# PROPOSED SITE IMPROVEMENTS

RE: JMC Project 22021  
26 Chestnut Ridge Road Improvements  
26 Chestnut Ridge Road  
Town of North Castle, New York

**Response to comments included in a Kellard Sessions Memorandum to the Town of North Castle Planning Department, Last Updated June 23, 2022:**

**SITE PLAN**

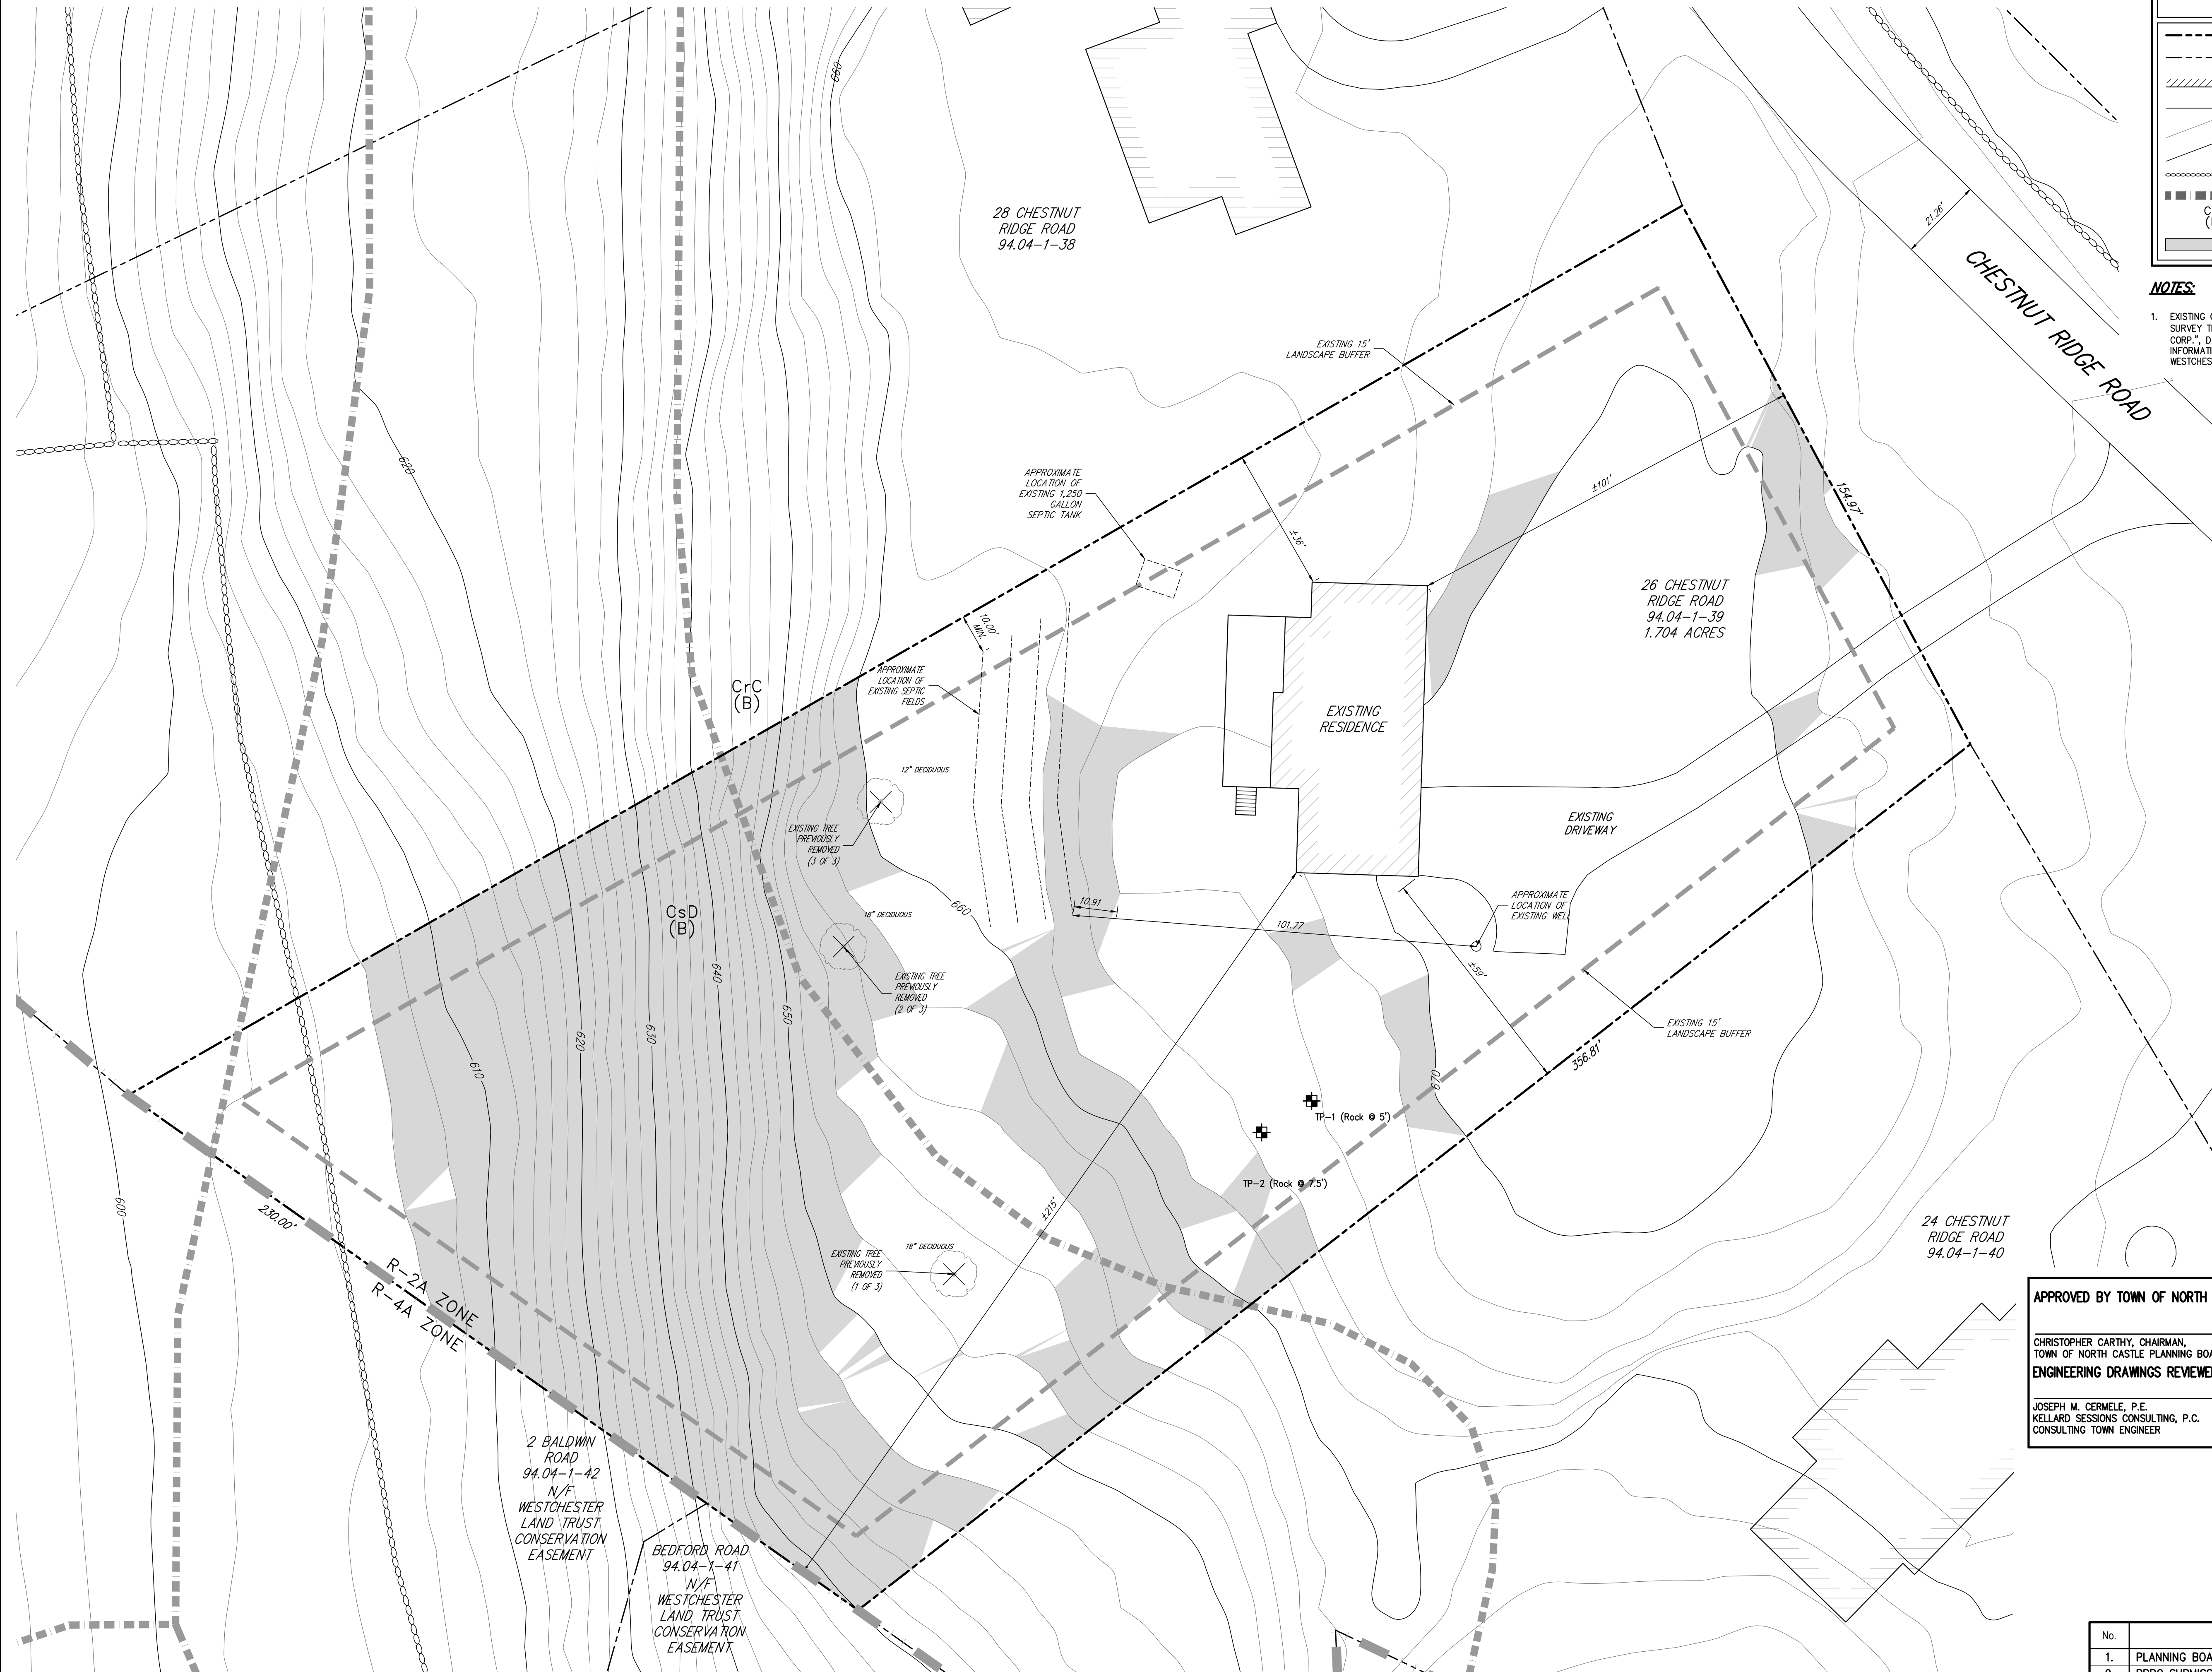
*Soil stabilization of the slope created by the fill should be stated as mandatory.*

A note has been added to JMC Drawing C-200 that states: "Hydroseed to be installed during construction on fill area and then seeded and mulched upon completion of construction."
